ADDENDUM NO. 5
TO
INVITATION FOR BIDS
IFB-21-HHL-009

HONOMU SUBSISTENCE AGRICULTURAL SUBDIVISION, PHASE 1

ADDENDUM NO. 5
IFB-21-HHL-009
Honomu Subsistence Agricultural Subdivision, Phase 1

C-2.0

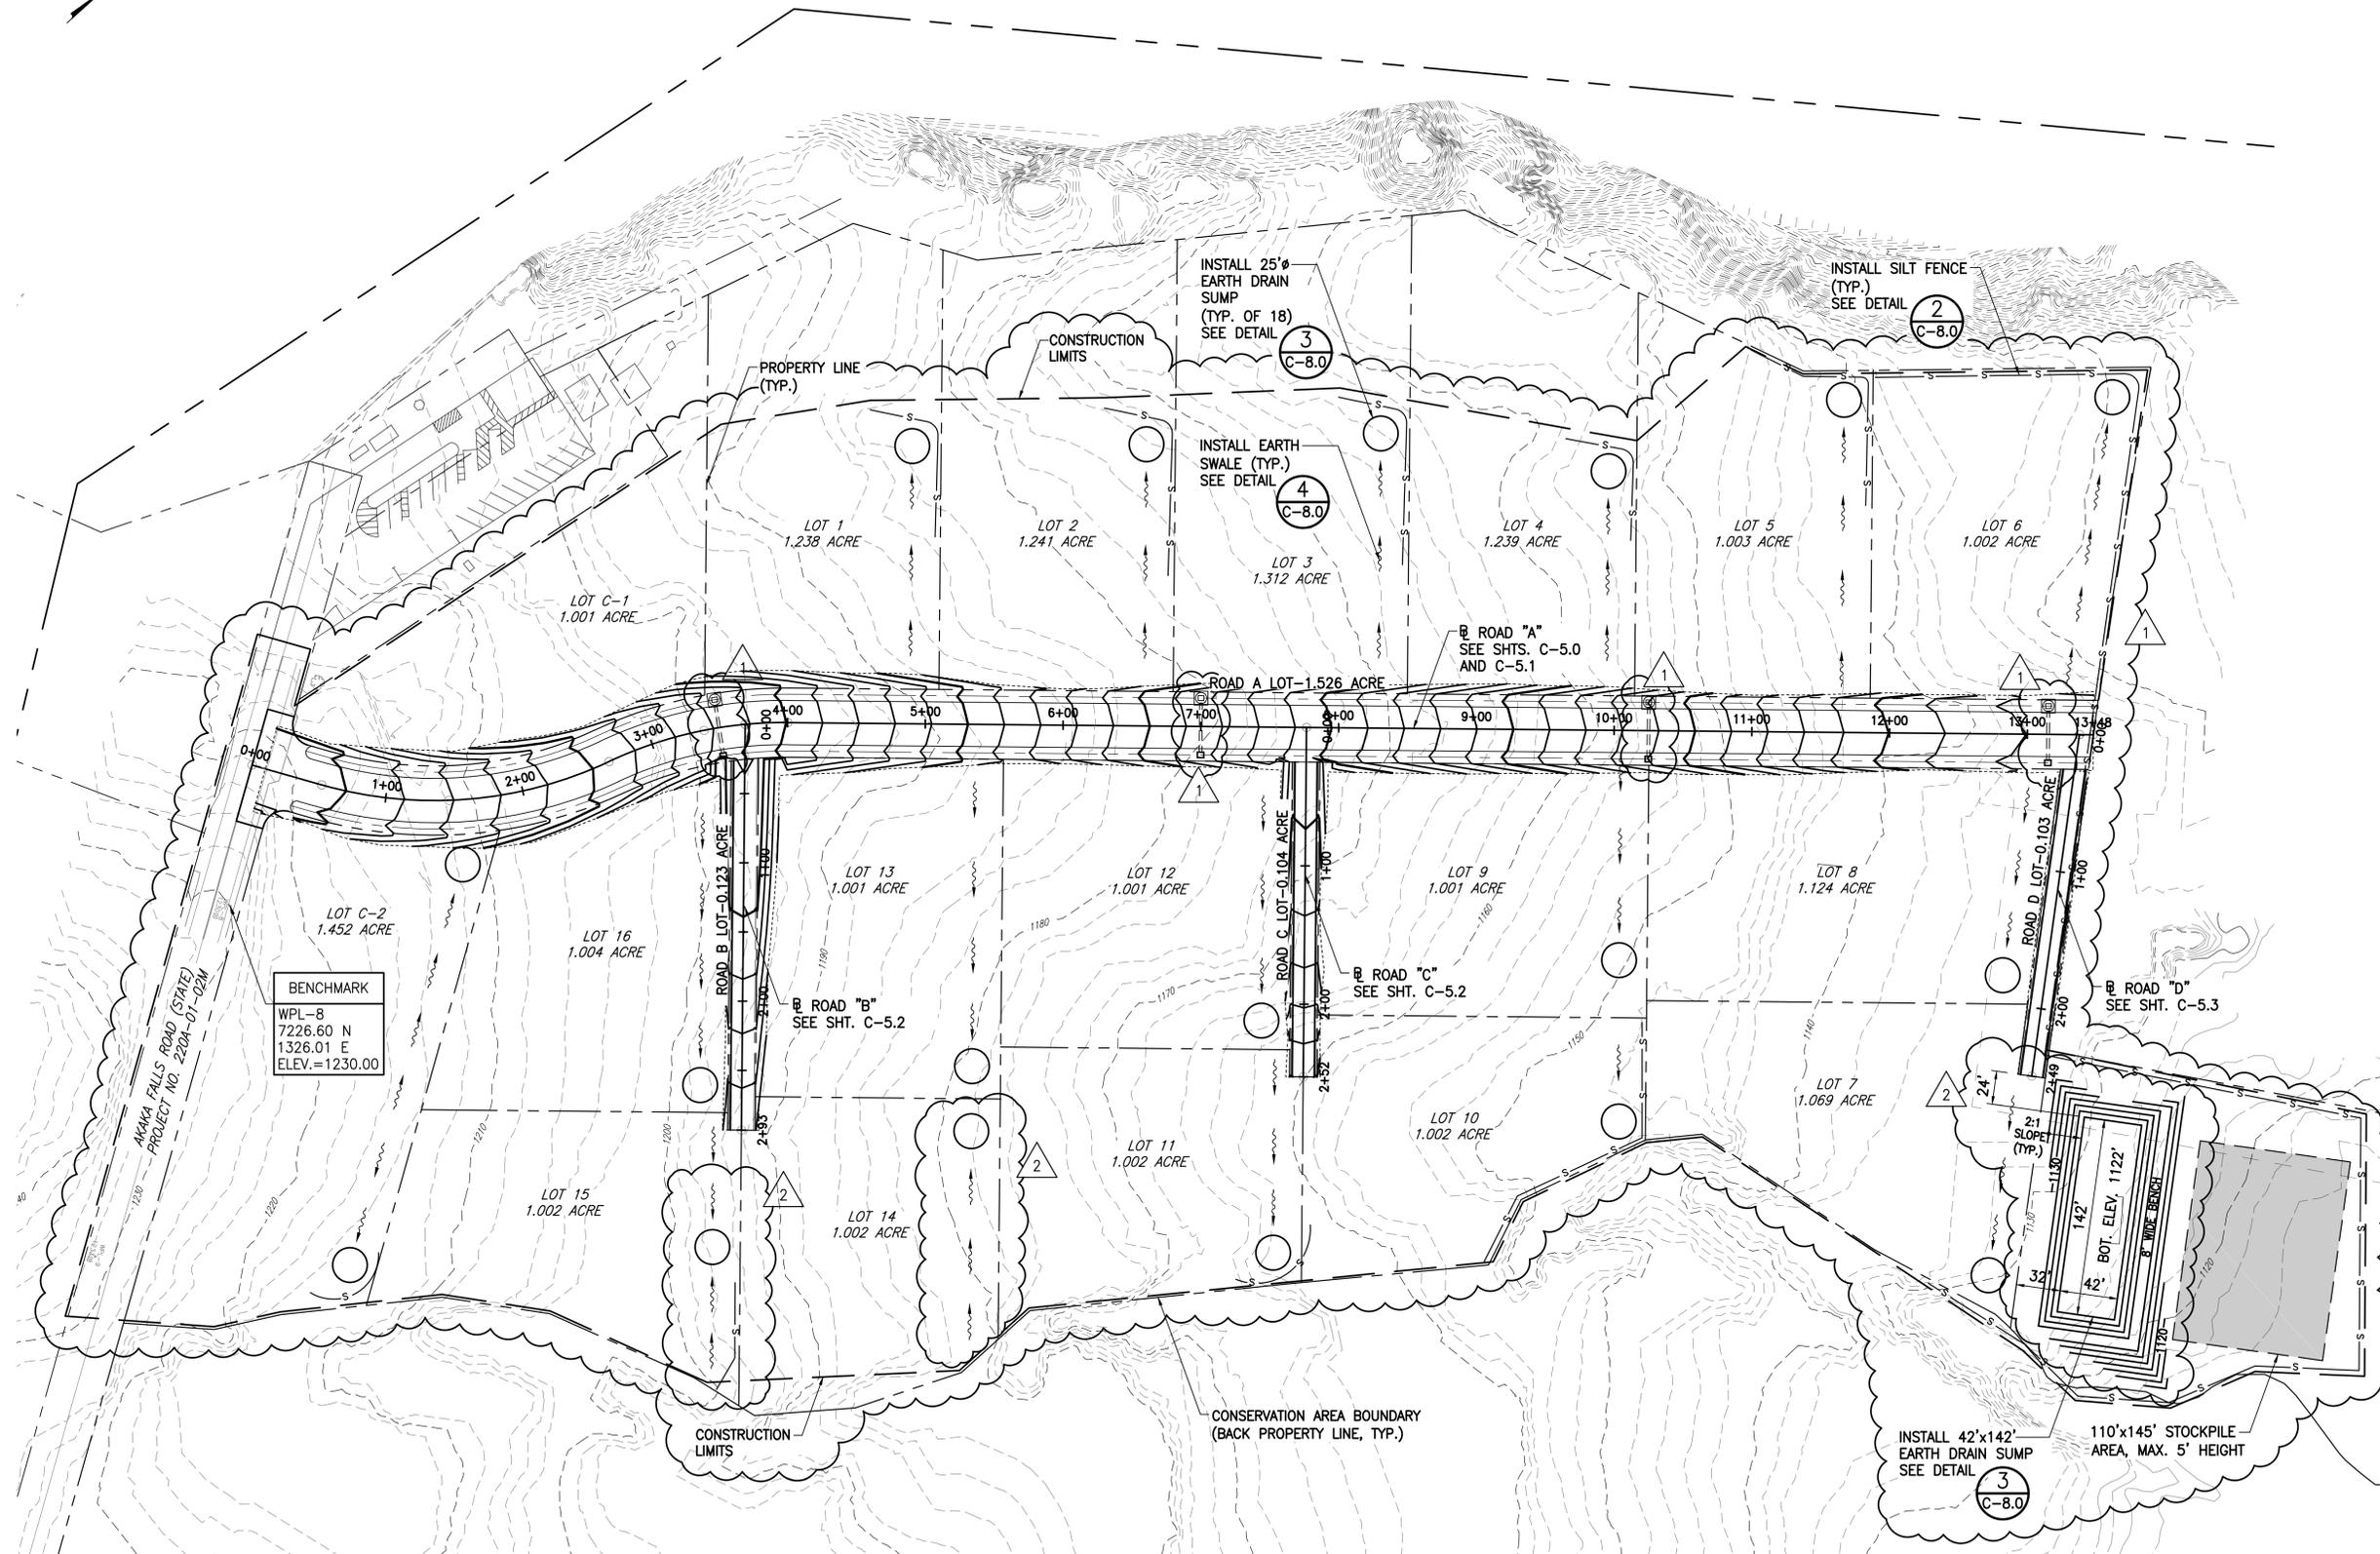
The attached Plan Sheet 4, C-2.0 shall replace the previous Plan Sheet 4, C-2.0.

6. Is the 30' x 170' Rectangular Earth Drain sump bottom to follow existing contours and be set at 5 ft below existing grade throughout bottom? - Large drain sump finish contours shown on grading plan now. See attached Addendum No. 5 drawings.

No.	Date	Description
1	11/24/20	RELOCATION AND/OR REDESIGN OF EARTH DRAIN SUMP
2	11/11/20	CONSTRUCTION AREA LIMITS AND LOCATION OF STOCK PILE AREA
3	10/29/20	REVISED INLET BOX AND DRYWELL
